Olympic Fashion Ltd

B.K.Bari, Mirzapur Bazar, Gazipur Sadar, Gazipur, Bangladesh
(24.105266, 90.402996)
15th October 2023

Observations

Absence of design documents

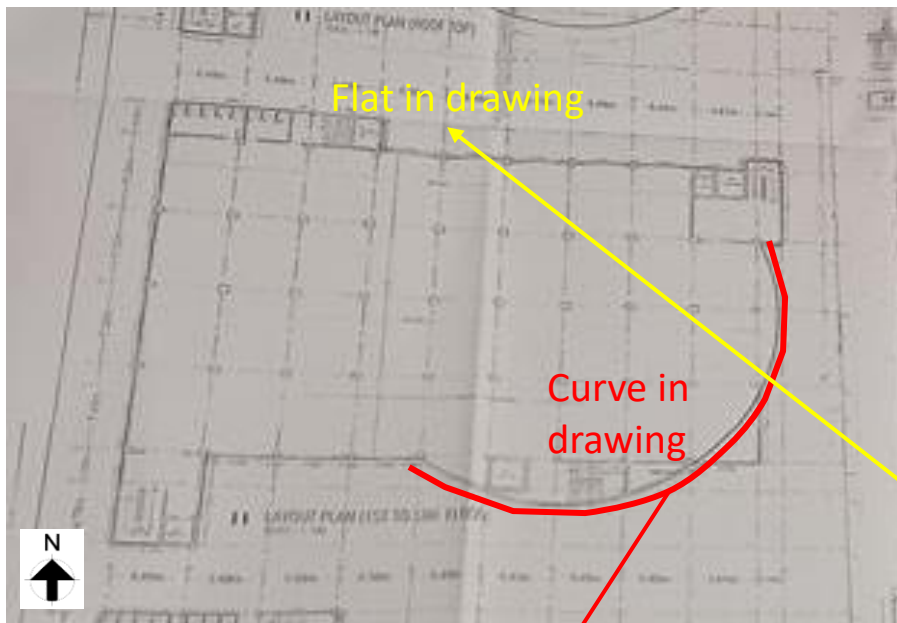
As per BNBC, every building or structure designed shall have its design documents prepared in accordance with the provision of Section 1.9.1. The design document shall include a design report, and a set of structural drawings, which shall be prepared in compliance with section 1.9.1.1 and section 1.9.1.2 as per BNBC.

At the time of inspection, design report was not available which is required to be prepared in compliance with section 1.9.1.1 (part-6, BNBC).

Corrosion on exposed rebar

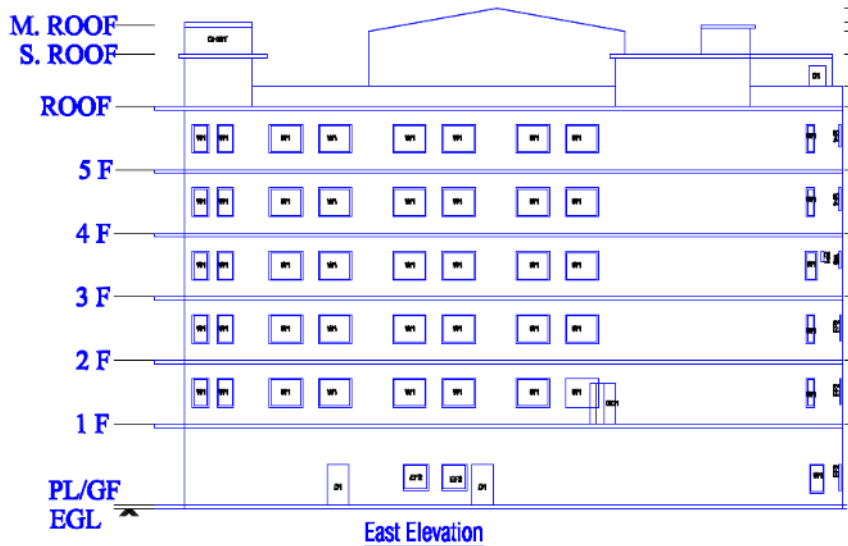
Exposed reinforcement left at roof (Main Building)

Factory is required to provide rust proof paint on exposed reinforcement to protect from corrosion.
